780-001-11

ADDENDUM NO. 1

Freeman Public Schools
 Adams, Nebraska
 TCEP No.: 780-001-11

Addendum #01
 Supplemental Drawing: SDA-001
 Revision of Sheet: A1.00
 Date: 09/26/12

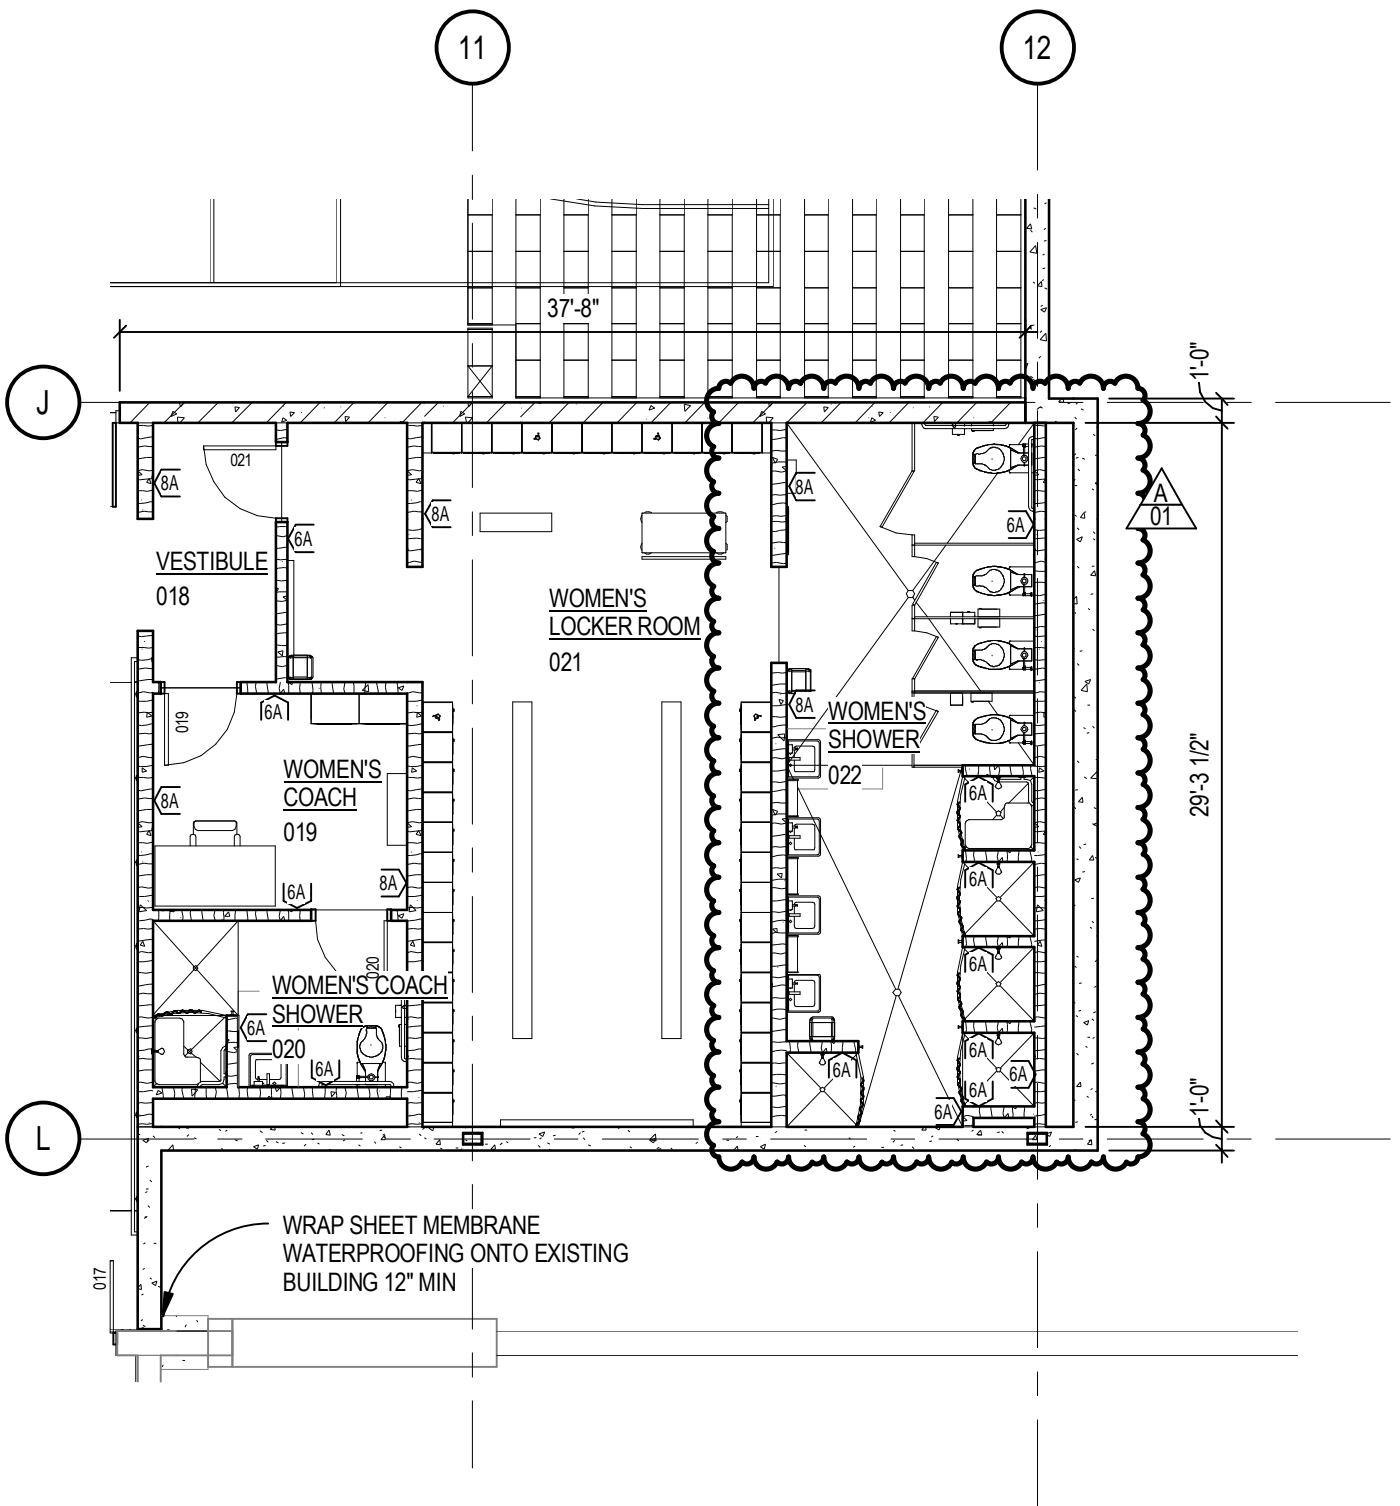
- a. Refer to attached supplemental drawing SDA-001 for changes to drawing. Changes to layout of Men's Shower 016.
- b. Refer to attached supplemental drawing SDA-002 for changes to drawing. Changes to layout of Women's Shower 022.
- c. Refer to the Equipment Schedule, item SB-1 Scoreboard shall be Contractor provided and installed, not owner provided.

Addendum #01
 Supplemental Drawing: SDA-003
 Revision of Sheet: A1.10
 Date: 09/26/12

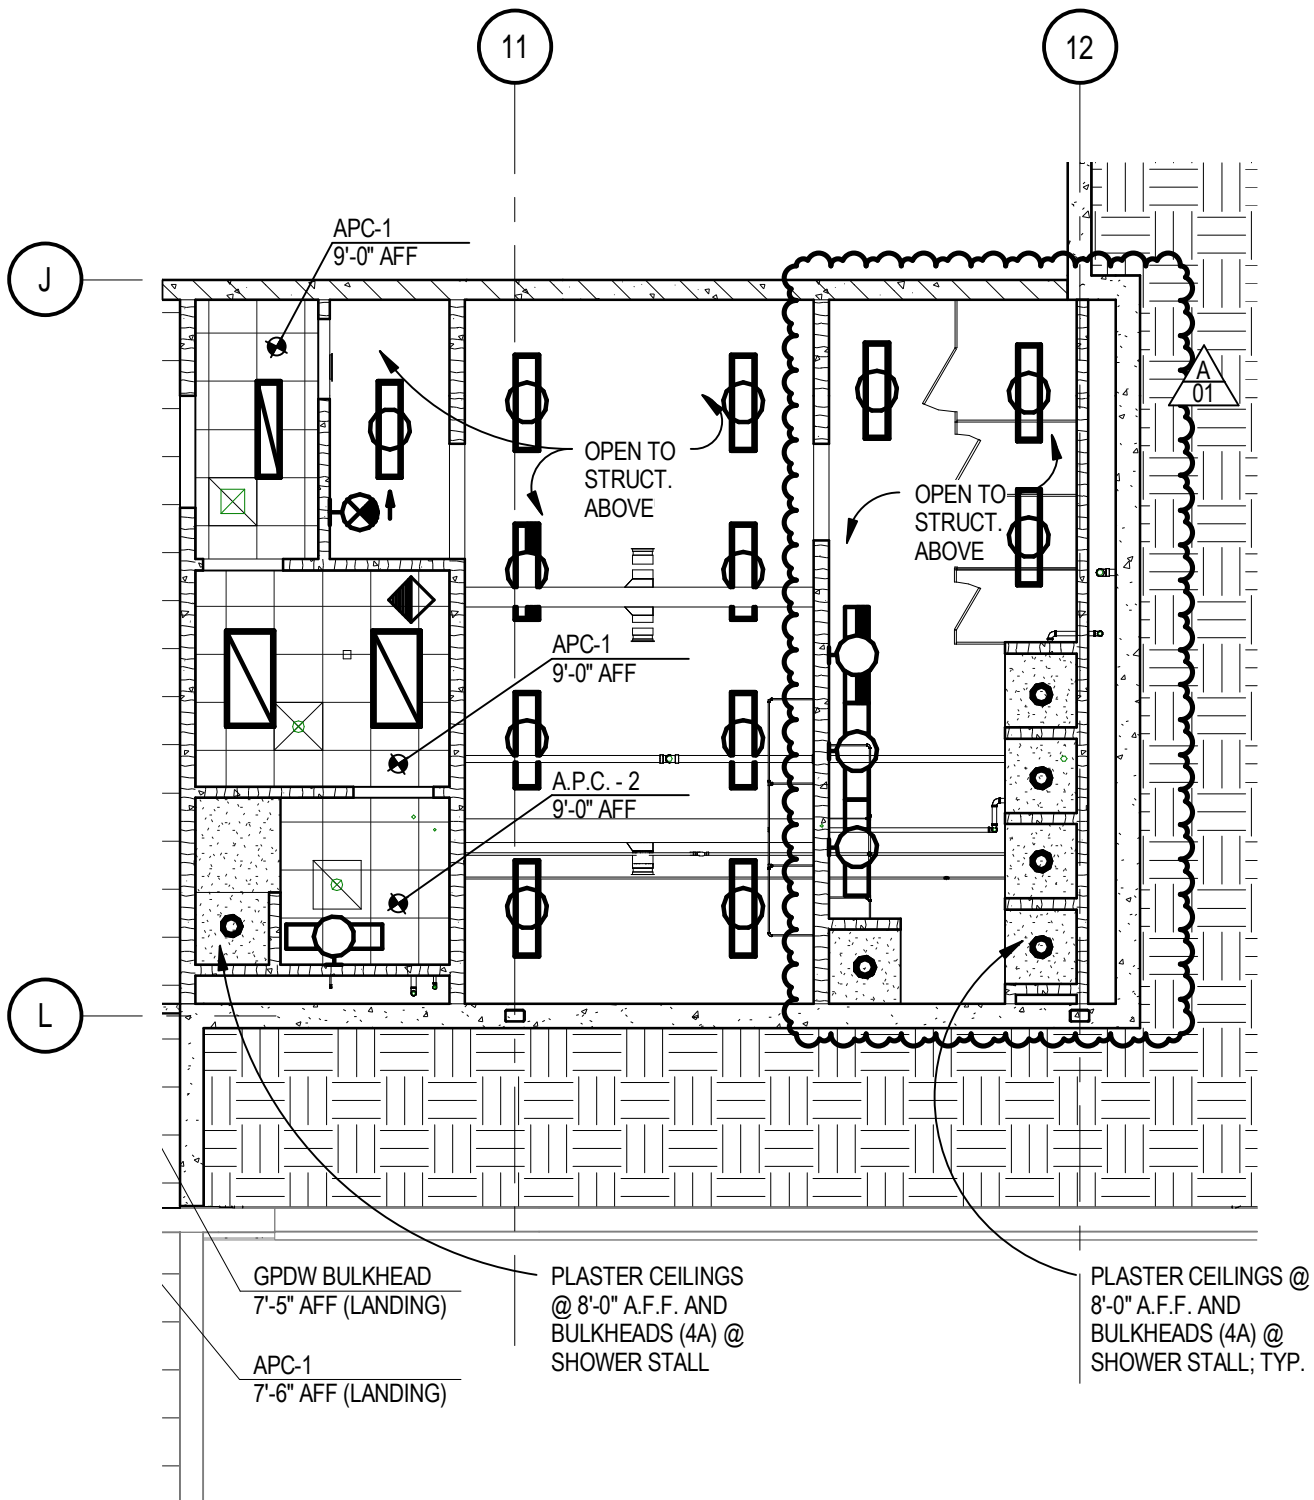
- a. Refer to attached supplemental drawing SDA-003 for changes to drawing. Changes to ceiling layout of Men's Shower 016.
- b. Refer to attached supplemental drawing SDA-004 for changes to drawing. Changes to ceiling layout of Women's Shower 022.

Addendum #01
Supplemental Drawing: SDA-005
Revision of Sheet: A6.01
Date: 09/26/12

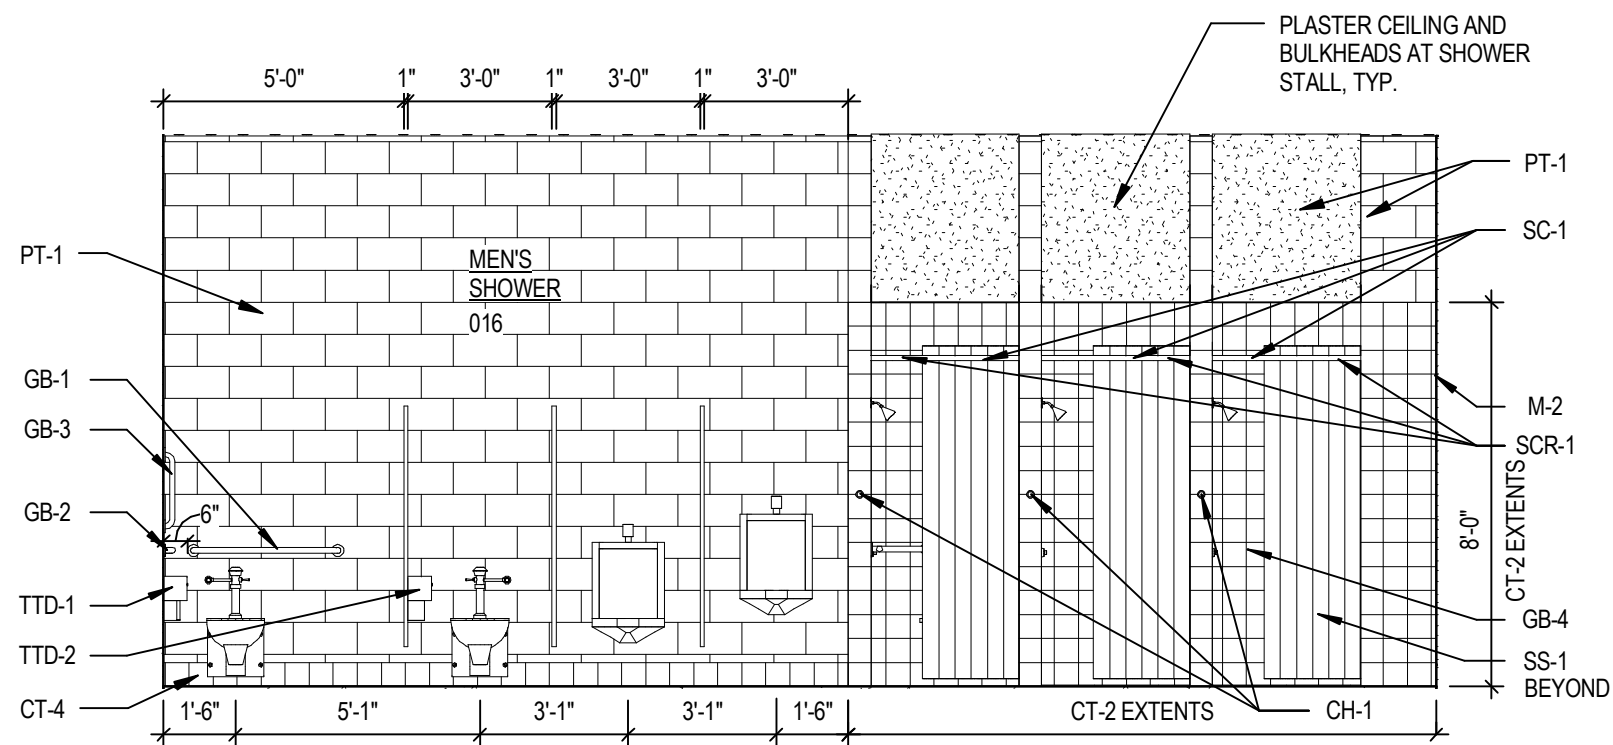
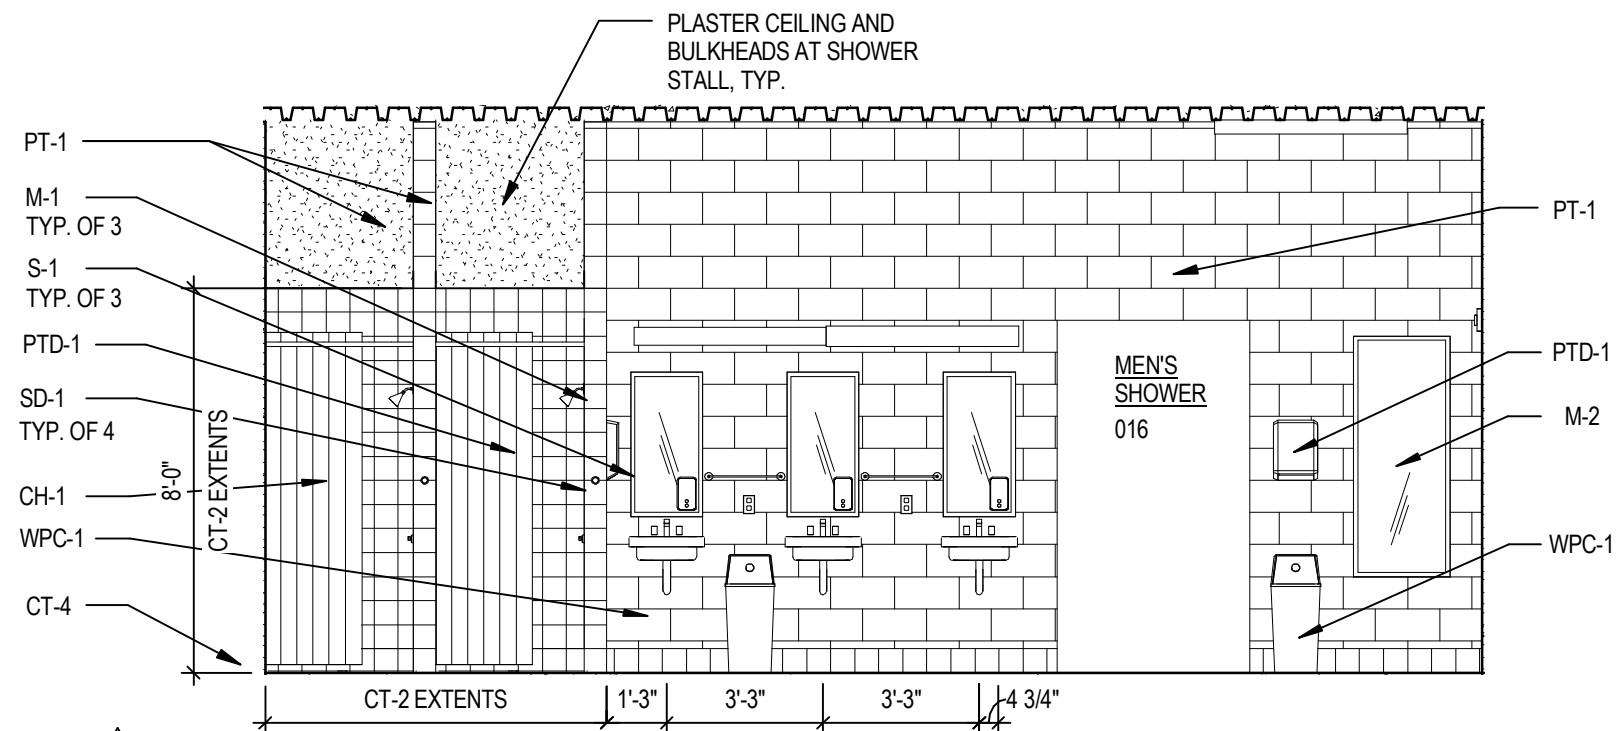
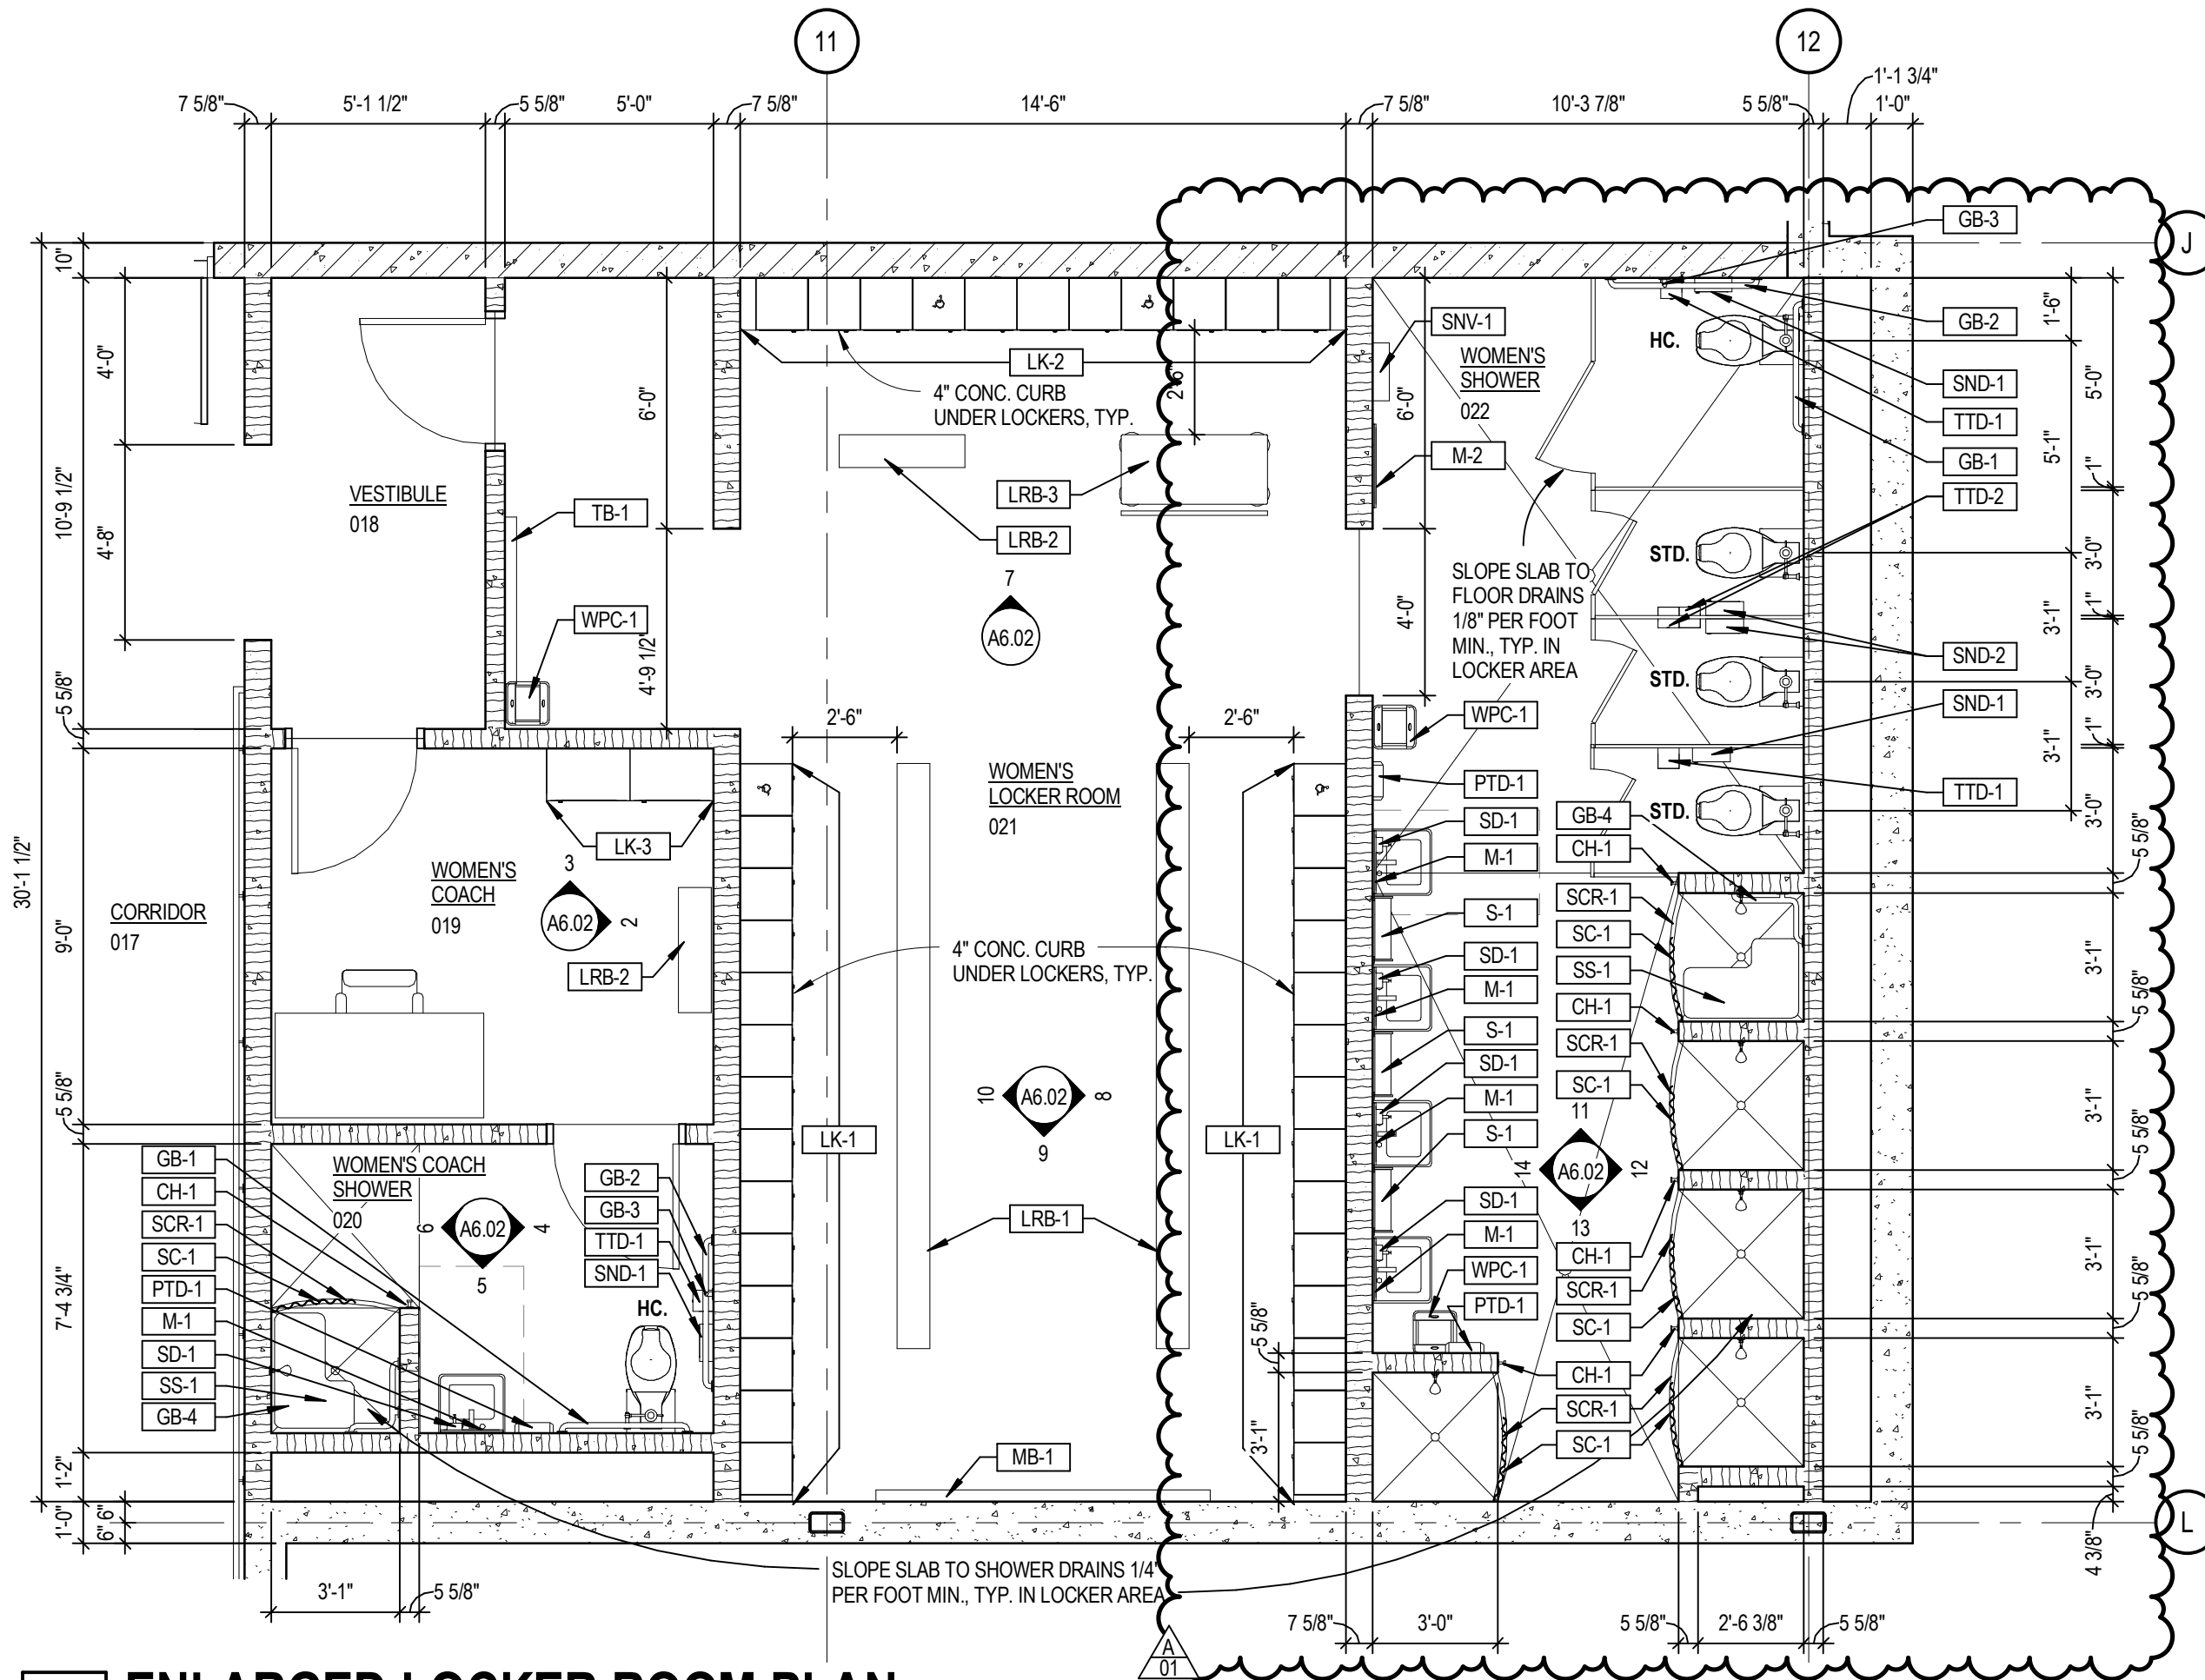
- a. Refer to interior elevation #6 - 014 – North Wall; Change CT-1 to read CT-4.
- b. Refer to attached supplemental drawing SDA-005 for changes to drawing. Changes to layout of Men's Shower 016.
- c. Refer to attached supplemental drawing SDA-006 for changes to drawing. Changes to interior elevation of Men's Shower 016. Elevation #13 - 016 – West Wall; Elevation #14 - 016 – North Wall.
